Hurricane Planning Commission Meeting Agenda

December 8, 2022
5:00 PM

Agenda Date:	12/08/2022
Application Number:	2022-PP-24
Type of Application:	Preliminary Plat Application
Action Type:	Administrative
Applicant:	Western Mortgage and Realty Co
Agent:	Brent Moser
Request:	Approval of a Preliminary Plat
Location:	South of Sand Hollow Road and West of 3700 W
Zoning:	Recreation Resort and RM-3
General Plan Map:	Planned Community

Agenda Date:	12/08/2022
Application Number:	2022-ZC-38 2022-PSP-47
Type of Application:	Zone Change and Preliminary Site Plan Application
Action Type:	Legislative
Applicant:	Shadow Glen 420 Inc
Agent:	Frank Lindhart
Request:	A Zone Change from RM-2 and HC to RM-3 and HC with a PDO
Location:	100 N 2600 W
Zoning:	RM-2 and HC
General Plan Map:	General Commercial and Multifamily

PRELIMINARY PLAT FOR:
GATEWAY AT SAND HOLLOW RESORT

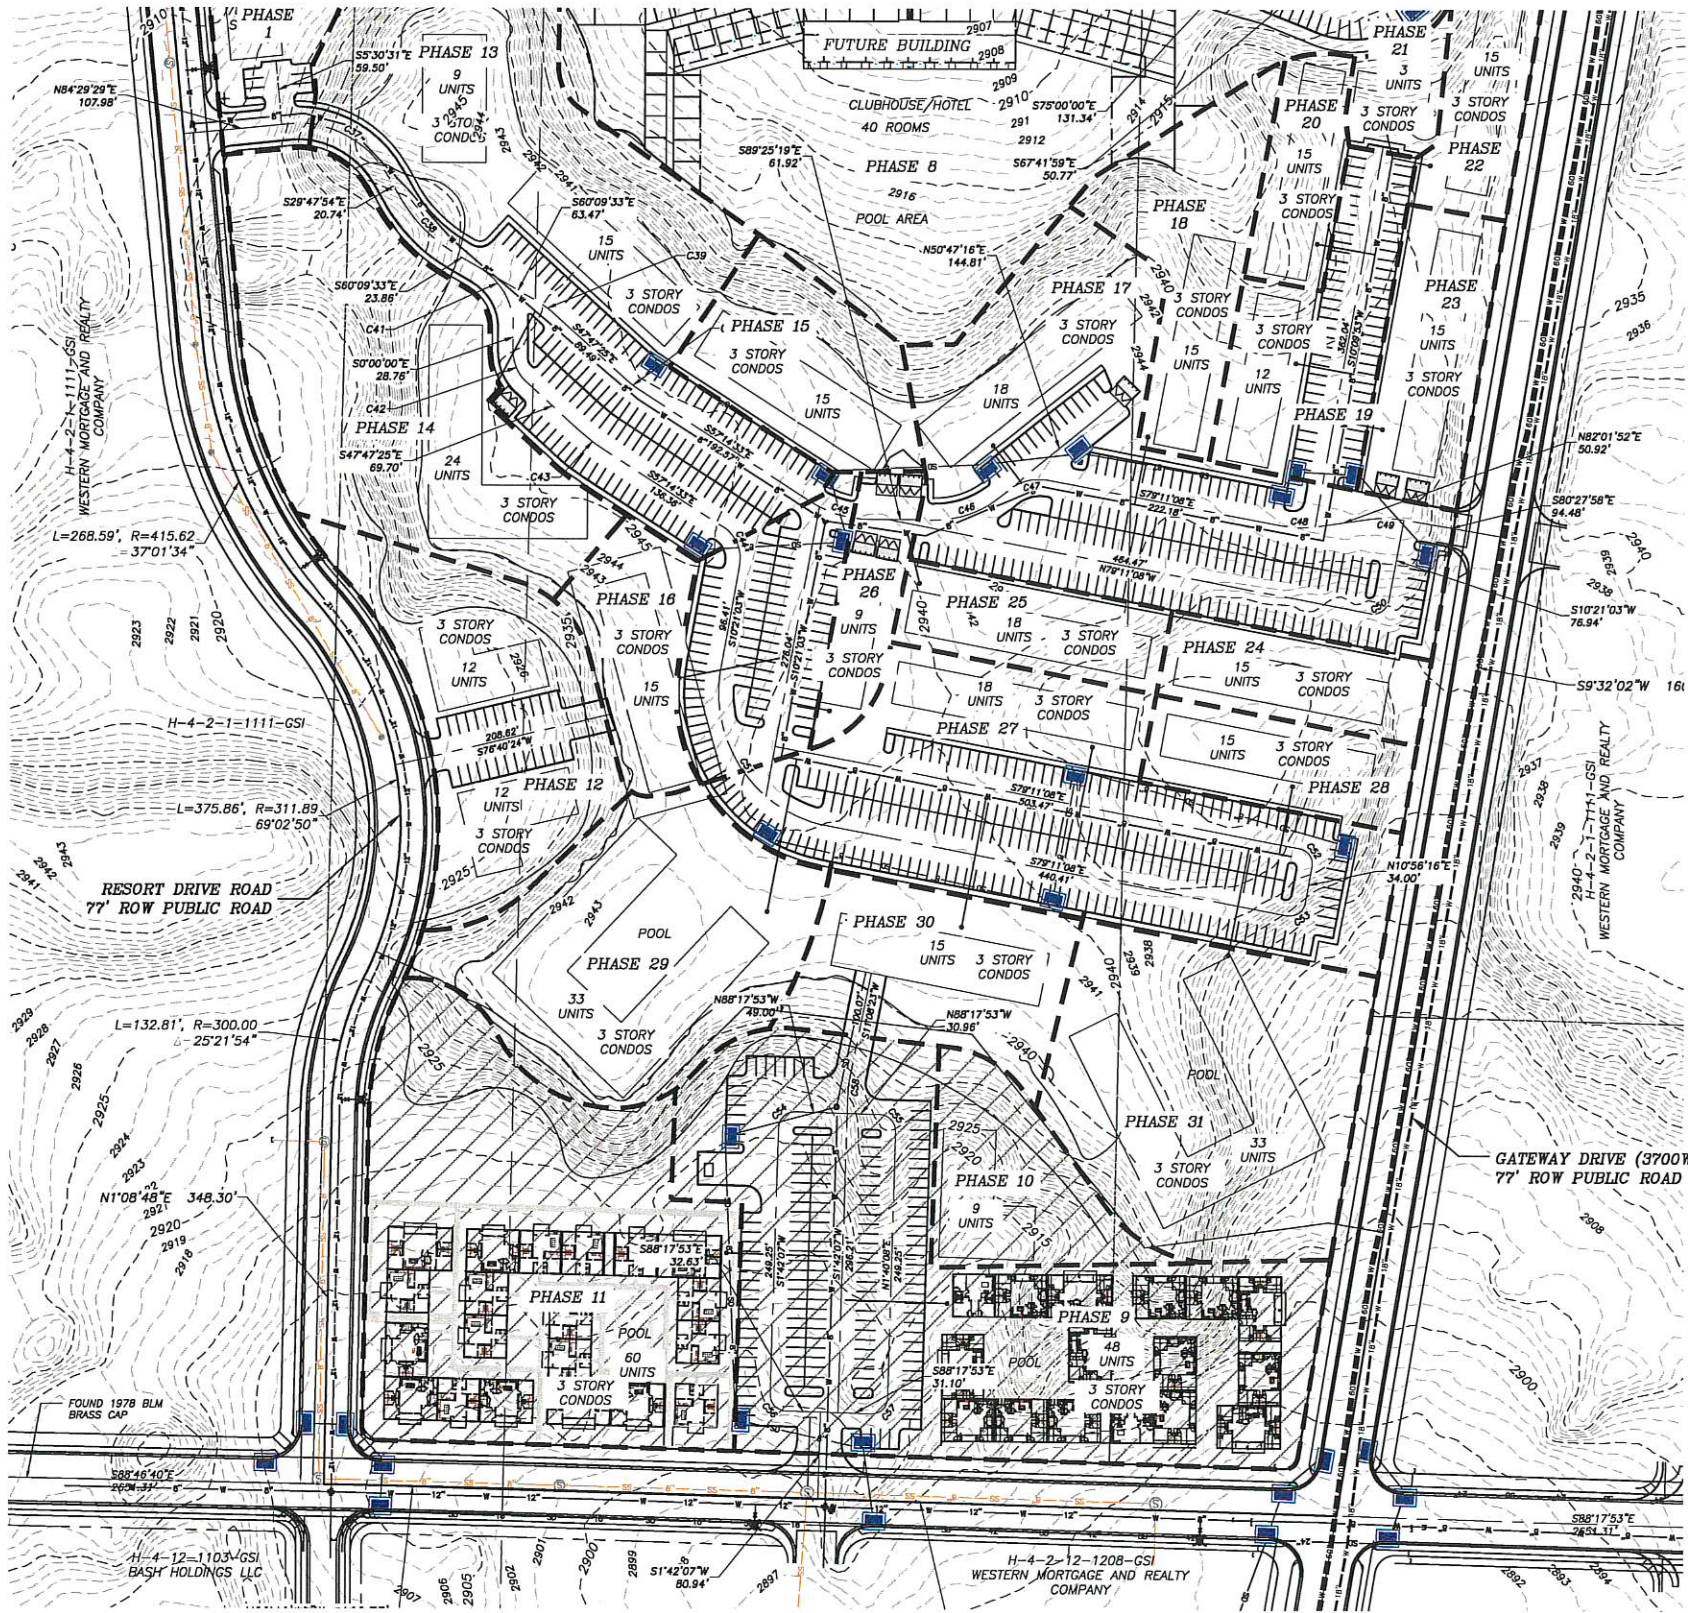
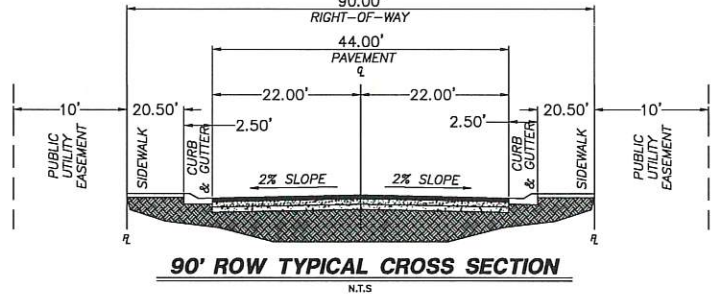
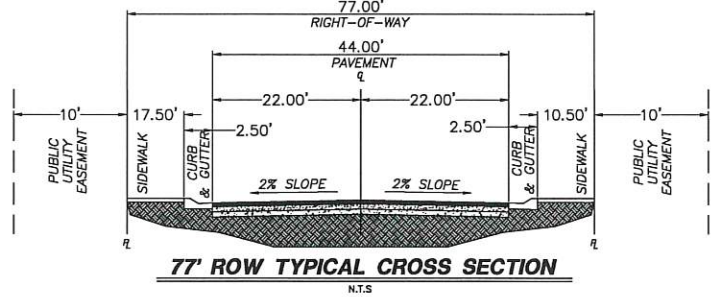
The applicant has requested that they be brought back on the agenda. They had initially been tabled due to a pending zone change. A zone change to bring the zoning boundaries into alignment with the planned roadways was recommended for denial by the Planning Commission with the recommendation that they add RM-3 zoning to the development and the City Council approved the zone change with the Planning Commission's recommendation. The zone change exhibit approved by the Council is attached to this report. With the approved zone change the preliminary plat has been updated. This resolves the zoning issues on the property however the following issues have still not been addressed:

- The approved zone change exhibit shows 810 resort units and 114 RM-3 units and the proposed preliminary plat shows 882 resort units and 117 RM-3 units. The application will need to resolve the density at issue prior to approval.
- Staff note 2 (parking) has not been addressed. As laid out below, staff does not believe their plan to meet their trailer parking requirement on a site near Sand Hollow Lake will be able to meet City Code

- They have added a note regarding the amenity requirements in Chapter 26 of the Hurricane City Code. They say they are providing 4,000 sq ft of clubhouse space, however as laid out below 5,500 sq ft are required.
- Will serve letters have not been received
- Site data table on page 2 directly contradicts information on page 1
 - Land Use Summary Table on Page 1 has several errors and inconsistencies
- Other comments within this report are still applicable except those regarding zoning which was resolved with the zone change.

should use a standard engineer scale for more detailed sheets 1"=60' is the largest standard scale. Legal description is incorrect. Block lengths exceed 800' additional public ROW are needed to reduce block size, provide additional fire access, and provide locations for water looping. Some buildings in phase 13 will be hard to access because of grades. Proposed cross-sections do not match standard cross-sections and it is not clear which roads these are for. It appears greater consideration for existing grades should be given: several roads will be over 10% grade, Phase 31 building will require over 30' of fill in order to work.

- a. The approved zone change map for this area shows 59 acres of Recreation Resort which would be 885 units. Part of the property being depicted on this site plan stretches into the RM-3 zone to the west.

- a. The site plan indicates that parking spaces 3091 are required and 3091 spaces are provided in a mix of outdoor parking and indoor garage parking.

- b. RV/trailer spaces are also required at a rate of one space per five units. 189 trailer parking stalls are required. The applicant has told staff that they intend to provide these parking spaces in an area offsite closer to Sand Hollow Reservoir. The Planning Commission does have authority under HCC 10-34 to approve off-site parking or modified parking requirements. Without a specific plan of where the parking will be located, how many spaces are provided, and how people will get from the offsite location to the site, staff does not recommend the approval of the parking plan as presented.

Recommendation: Staff recommends the Planning Commission review this application based on standards with Hurricane City Code. Due to the issues of zoning (currently under consolidation), parking, lacking will-serve letters, redesign of Sand Hollow Road, and amenities; staff recommends denial or tabling of this preliminary plat until all the issues raised can be adequately addressed.

Hurricane City Future Land Use Map with site plan overlaid

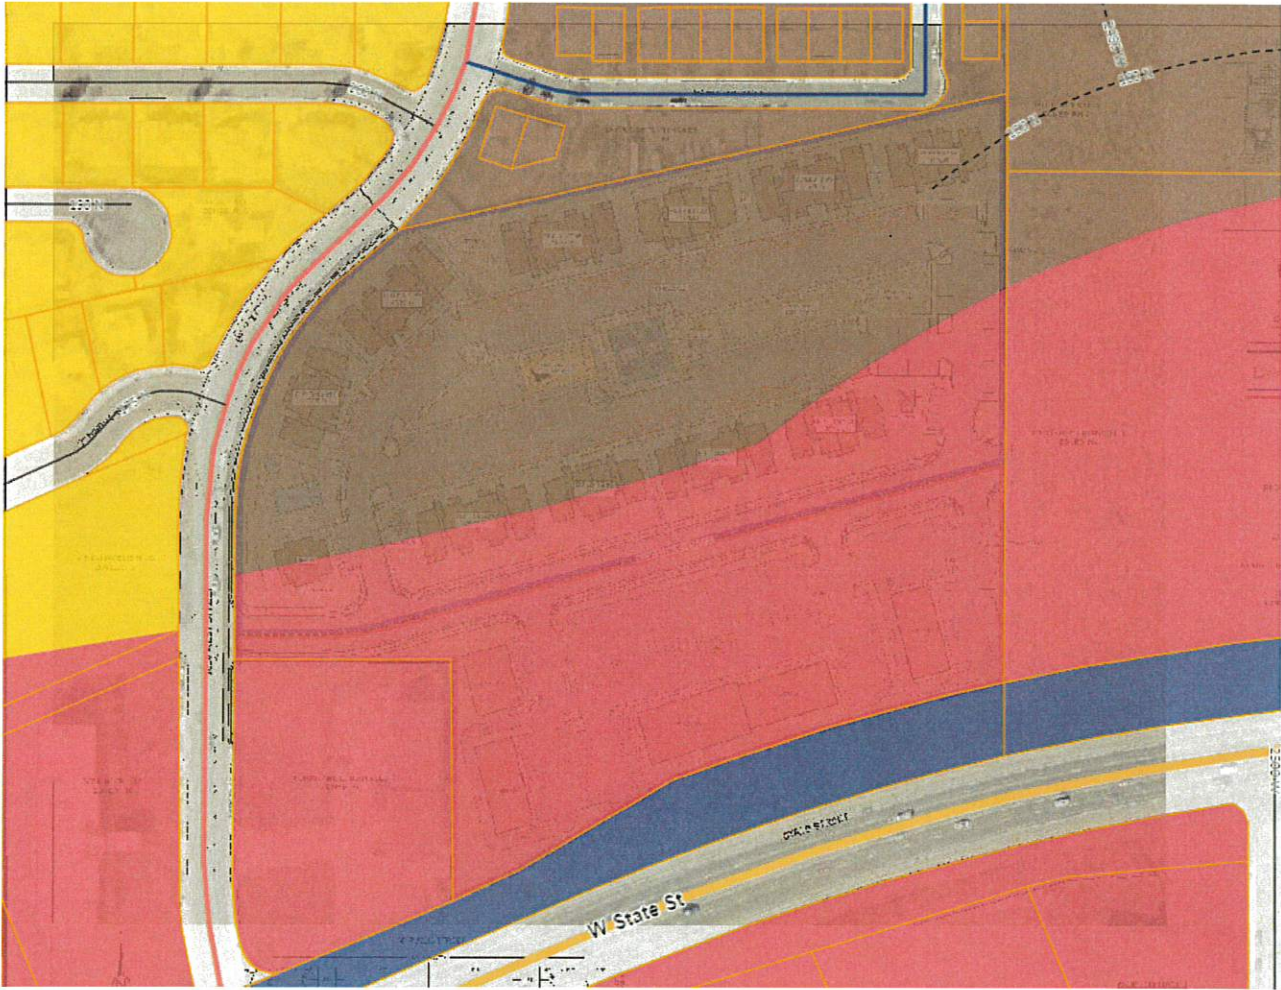
The General Plan Map is meant to be used as a guideline for future development however, this development appears to follow the lining on the map fairly closely.

The lining on the map follows the future 100 N master plan roadway (the alignment is addressed later in this report). Overall staff believes this lines up with the spirit of the General Plan.
